REPORT TO THE BELOIT LANDMARKS COMMISSION

File Number: COA-2010-23

Applicant: Beloit College

BELOIT COLLEGE SIDEWALK & PARKING IMPROVEMENTS
 CITY OF BELOIT
 ROCK COUNTY, WISCONSIN
 30010.DWG

OVERVIEW

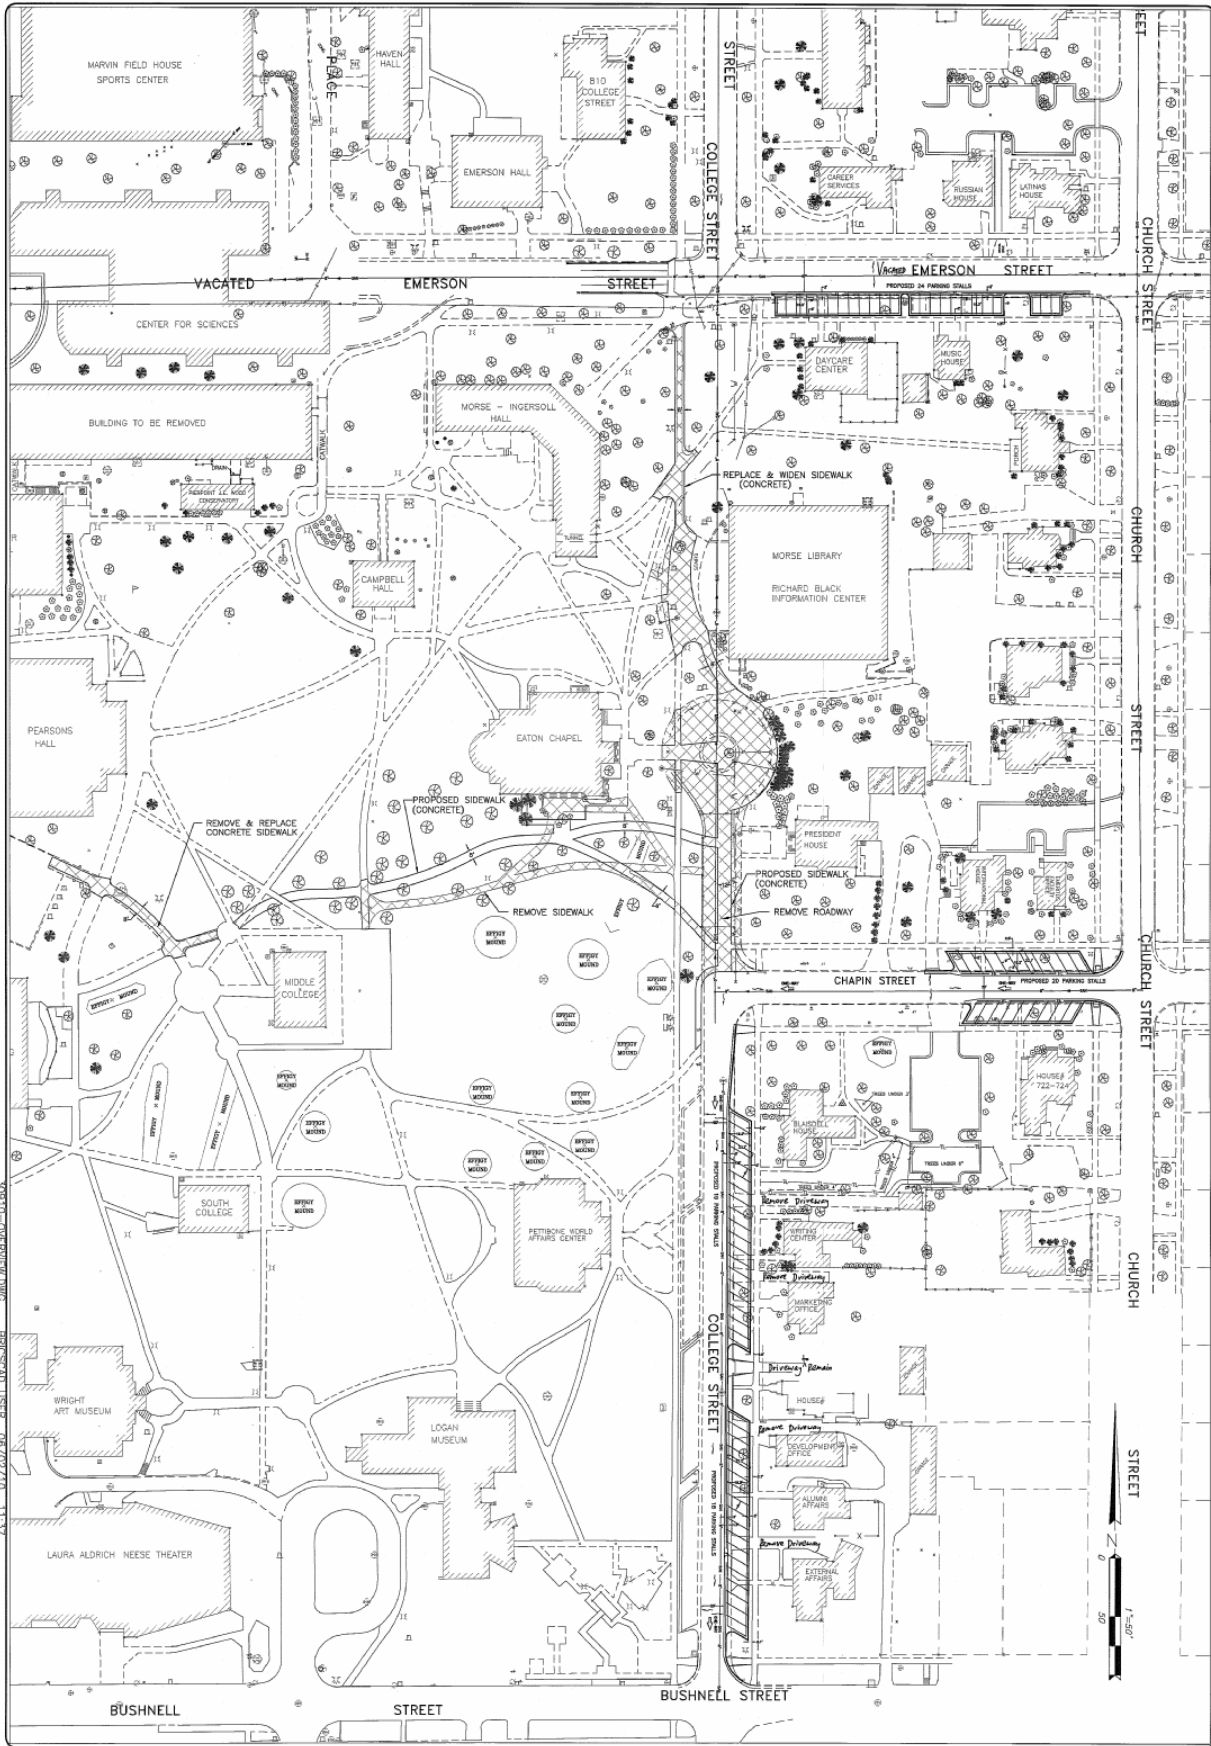
- The attached Overview Plan shows the proposed changes.
- The 700 block of Emerson Street right-of-way was vacated in 2006, which means that the area was transferred back to the adjoining properties. Because the adjoining properties are located in the historic district, a COA is required.

- Several photos of the vacated portion of Emerson Street are attached to this report. According to the Overview Plan and an inspection of the site, only one mature tree will be removed as a result of the additional parking on the properties located at 749 College Street and 716 Emerson Street.

- As shown on the Overview Plan, the applicant intends to replace, remove, widen, and/or install several sidewalks.
- In addition, the applicant intends to remove the private cul-de-sac adjacent to Eaton Chapel and Morse Library. The cul-de-sac will be replaced with a wide (12') sidewalk and pavers that will maintain the fire lane.

- Because of the additional parking along the eastern side of College Street, the applicant has proposed the removal of several driveways and portions of several sidewalks, as shown on the Overview Plan. The driveway for the only remaining private residence (623 College Street) will remain. The multi-stall garage on the property located at 619 College Street will be accessible from Bushnell Street, and the applicant has proposed additional parking stalls in the grassy area behind the buildings located at 619 and 613 College Street.

1. The existing tree on the eastern end of the proposed parking area shall be retained and protected during and after construction.
2. Prior to beginning construction of the parking stalls, the applicant shall obtain a Certificate of Zoning Compliance.

3. The applicant shall maintain a twenty (20) foot fire lane through the area currently occupied by the private cul-de-sac.
4. The proposed sidewalks shall be constructed of cement and shall be at least six (6) feet wide.

5. Following removal of each College Street driveway, the applicant shall plant a deciduous tree in its place whose trunk is at least two (2) inches in diameter when measured six (6) inches above grade and twelve (12) feet in height or greater when planted.
